April 17, 1968

BULLETIN NO. 1
to
SPECIFICATIONS
for
FINE ARTS CENTER - PHASE II
WILKES COLLEGE
Wilkes-Barre, Pennsylvania

BULLETIN NO. 2
to
SPECIFICATIONS
for
FINE ARTS CENTER - PHASE II
WILKES COLLEGE
Wilkes-Barre, Pennsylvania

BULLETIN NO. 3
to
SPECIFICATIONS
for
FINE ARTS CENTER - PHASE II
WILKES COLLEGE
Wilkes-Barre, Pennsylvania

DWG
SK-1

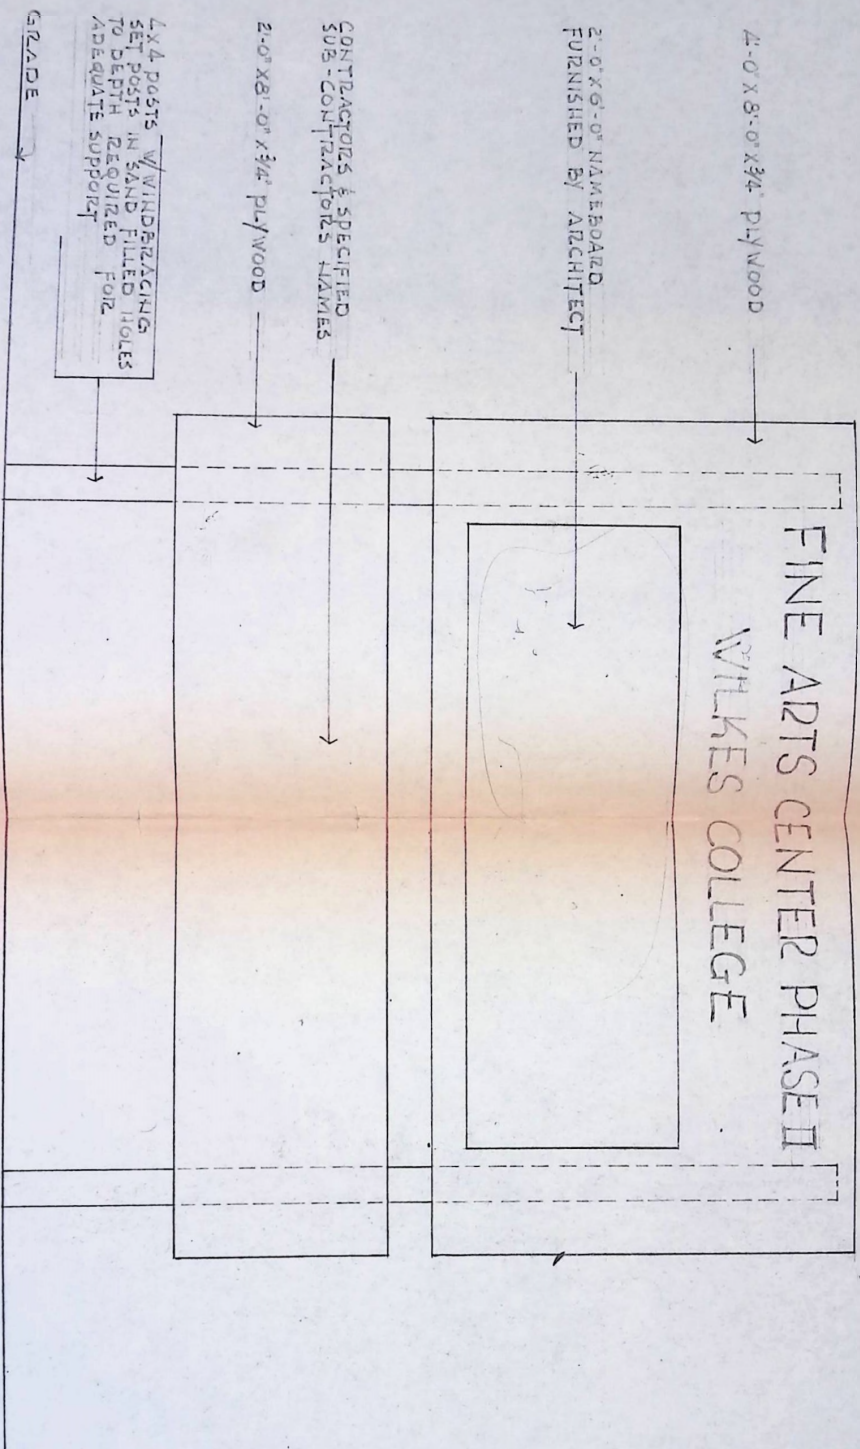
22. Paragraph 19.09 - Provide cylinders for operable walls.
23. Drawing No. SK-1 - (issued herewith) - Provide job sign as described in specifications and noted on this sketch.

DWG. NO. SK-2

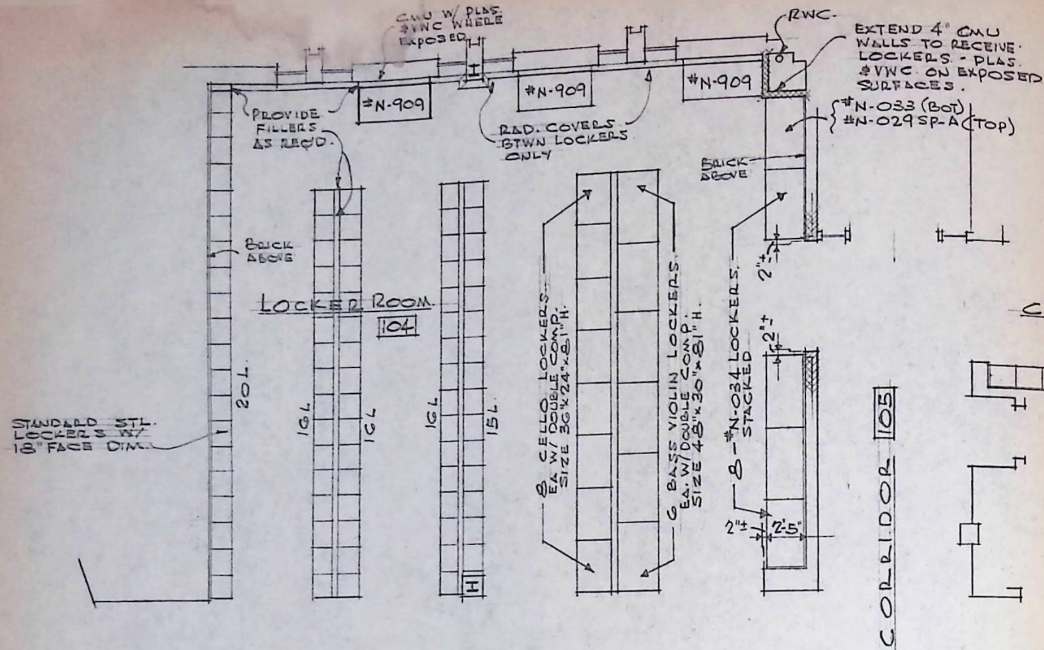
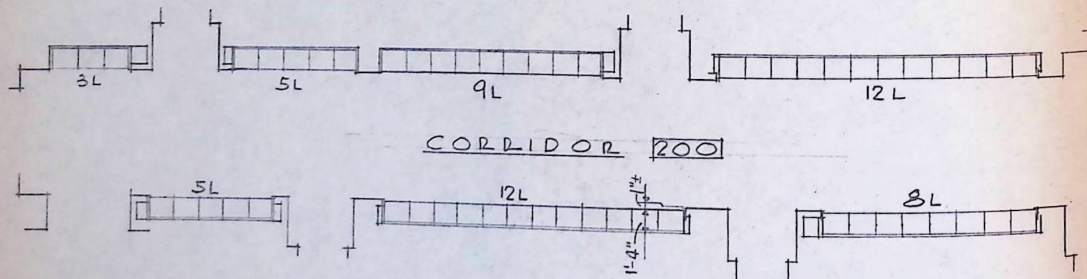
- 2-8 Paragraph 20.34 (a) - Provide body panels on three sides in lieu of two sides.
- 2-9 Drawing #SK-2 (enclosed herewith) Provide additional instrument lockers indicated on this drawing. All instrument lockers shall be of heavy gauge furniture steel and all doors shall have continuous hinges. Types of lockers shall be as indicated on the drawing and shall be as manufactured by Norren Manufacturing Company, P. O. Box 776, Arcadia, California. All lockers shall be numbered and colors shall be as selected by the Architect. Locks for each instrument locker shall be with a Master "Champ" #1654 key controlled combination lock.

- All necessary metal fillers shall be provided by the manufacturer of the instrument lockers. Shop drawings shall also be required.
- The General Contractor shall note changes in masonry work required by this drawing and changes in baseboard radiation covers.
